**Rother Valley Railway Transport & Works Act Order  
Footpath Diversion S&R 31 (SAL/31/1) Rail Levels**

**Approved Scheme**

**Changes to meet concerns over footpath under Bridge 12**

**Changes to meet Condition 20 Highway England Departures from Standard**

Drawing No. Revision  
**RVR - S - 001 B**

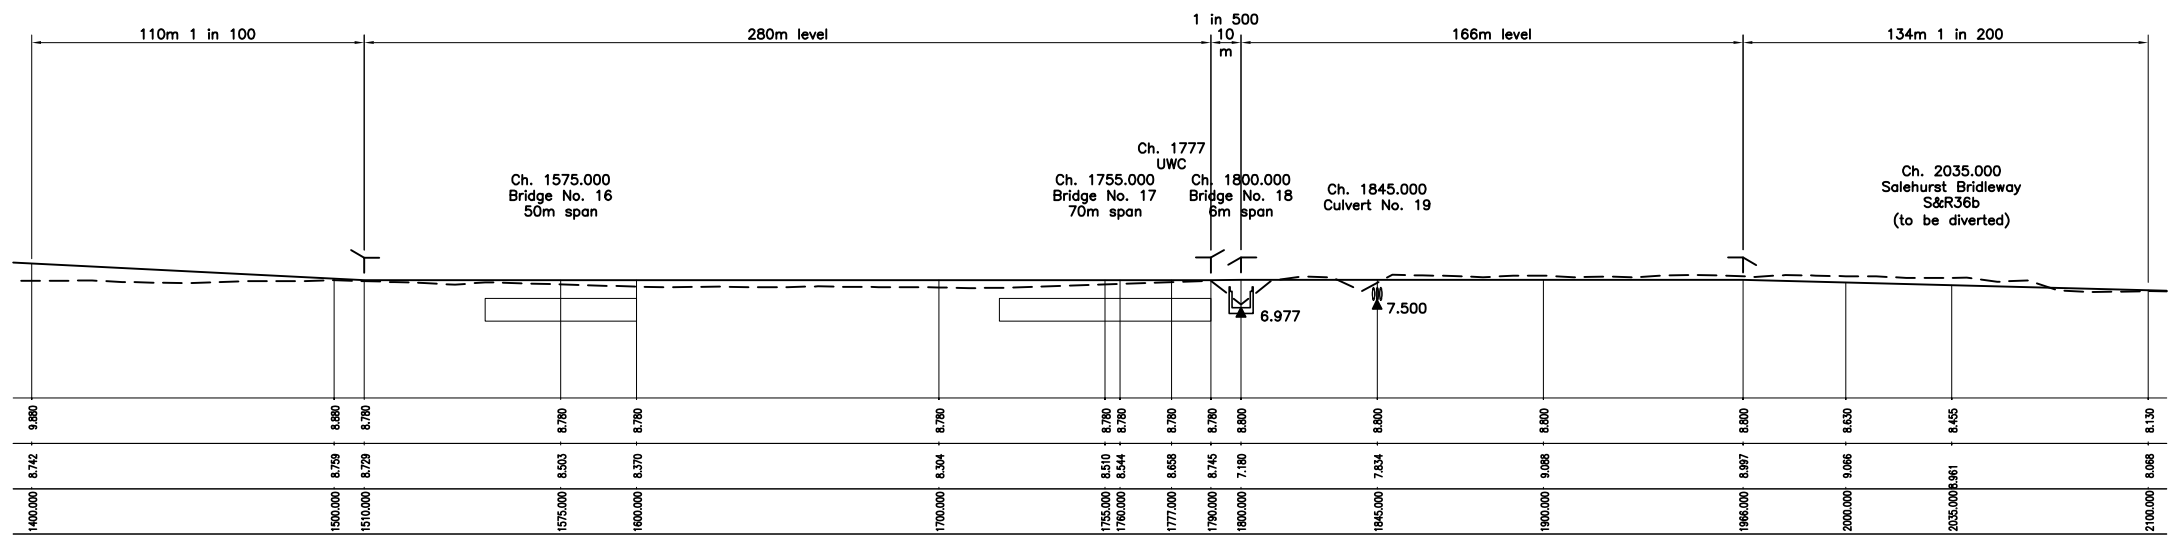
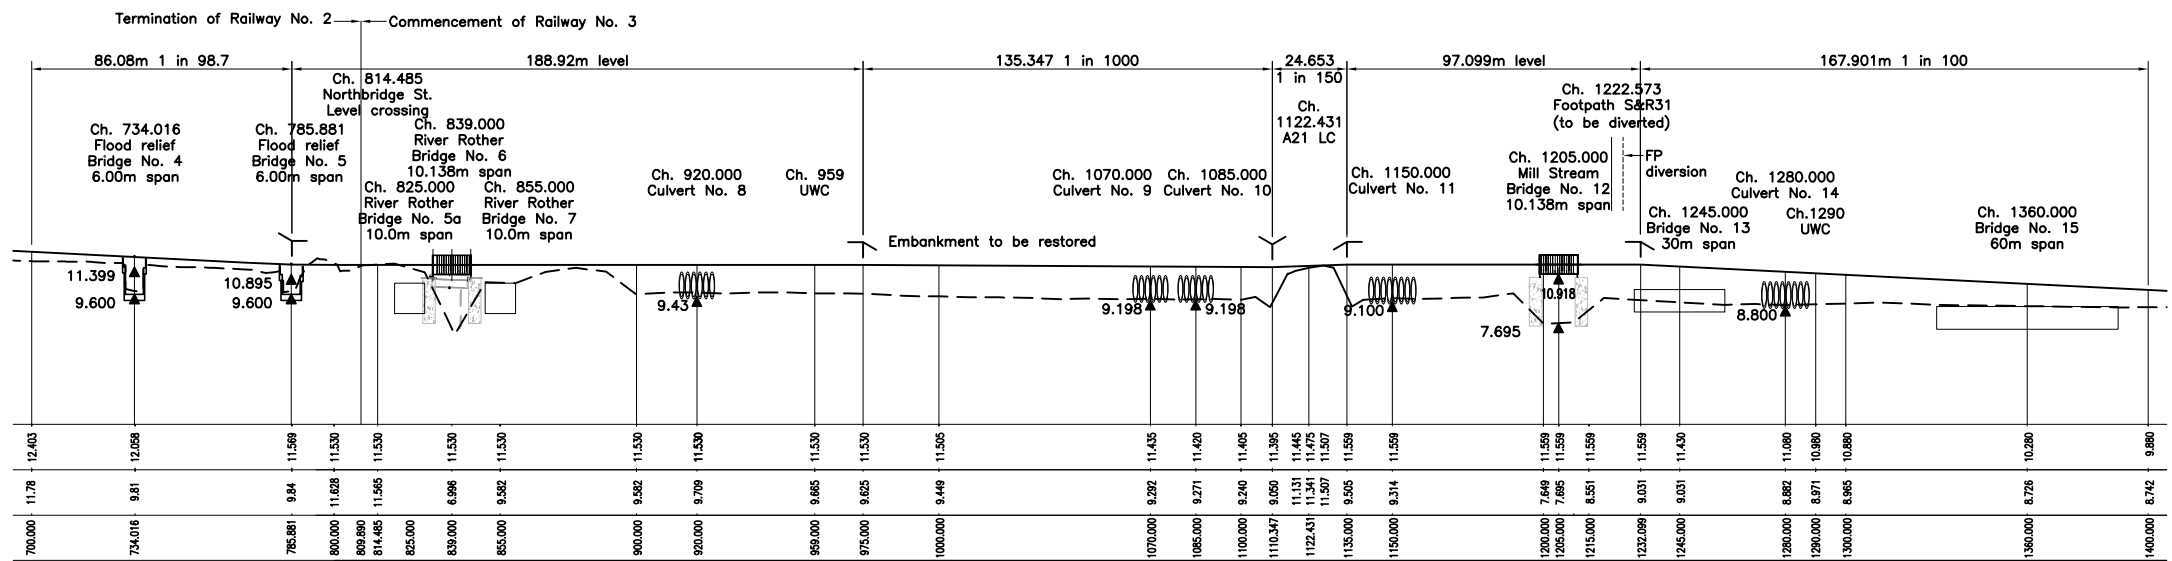
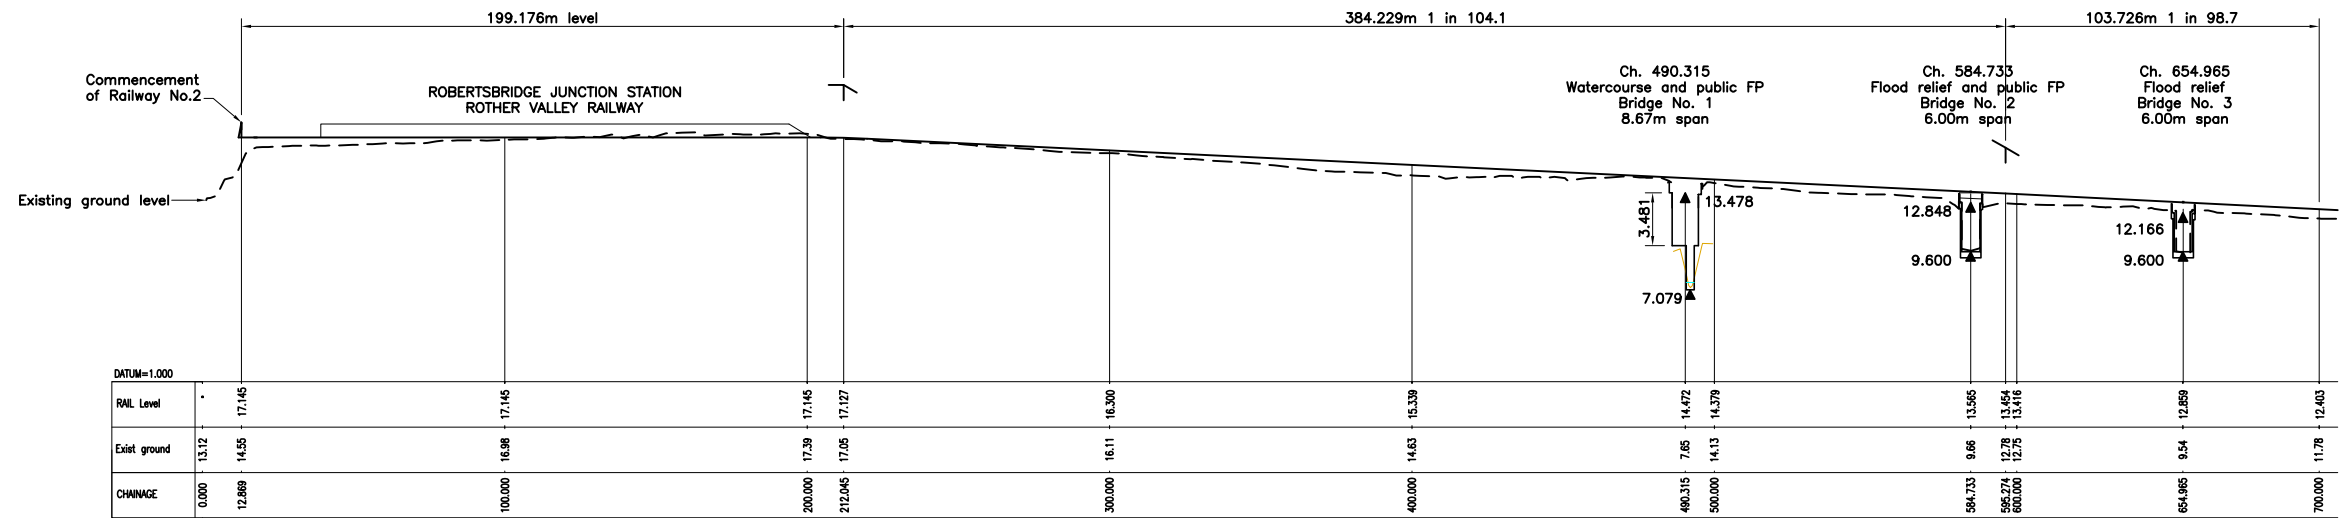
- 12 The design worked up with Highways England means that the railway now crosses the road at a 1:150 gradient rising eastwards to meet the East channel level as shown on drawing RVR-S-001b 2021-07-10 (attached at Appendix 7) at 11.507m AOD.

- 13 From the A21 east channel, the rail level continues to rise as it passes through a vertical crest curve of length 10m (shown as a "v" mark above the track) on drawing RVR-S-001b 2021-07-10 (attached at Appendix 7), attaining a level of 11.559m AOD. This is 0.189m higher than the profile level of 11.370m AOD at this point shown on the approved profile drawing at Appendix 3.

- 20 As no flood water is predicted to overtop the embankment at this location, if the rail level and embankment are raised to 11.559m AOD as shown in drawing RVR-S-001b 2021-07-10 the revised section, see paragraph 13 above (attached at Appendix 7), the additional height will not be obstructing any flow over the railway. There may be a small increase in the volume of material added to the floodplain below the 1% AEP climate change flood level due to the potential adjustments required to the embankment slope to accommodate the higher rail level. This would be mitigated through floodplain storage compensation or adjustments within the detailed design of the embankment.

- 21 The revised rail level would be 11.559m AOD at the Mill Stream. Drawing RVR-S-001b 2021-07-10 shows how the proposed rail level would return to the previously proposed

level (approx. 11.1m AOD) to the west of bridge 14. At this location the predicted flood level of 9.98m AOD (1% AEP with 105% allowance for climate change design flood event) is also below the top of the embankment, so for the short section where the proposed rail levels would be adjusted the additional height will not be obstructing any flow over the railway. As such there would be no significant impact on predicted flood levels and the conclusions of the 2021 Flood Risk Assessment would not change.
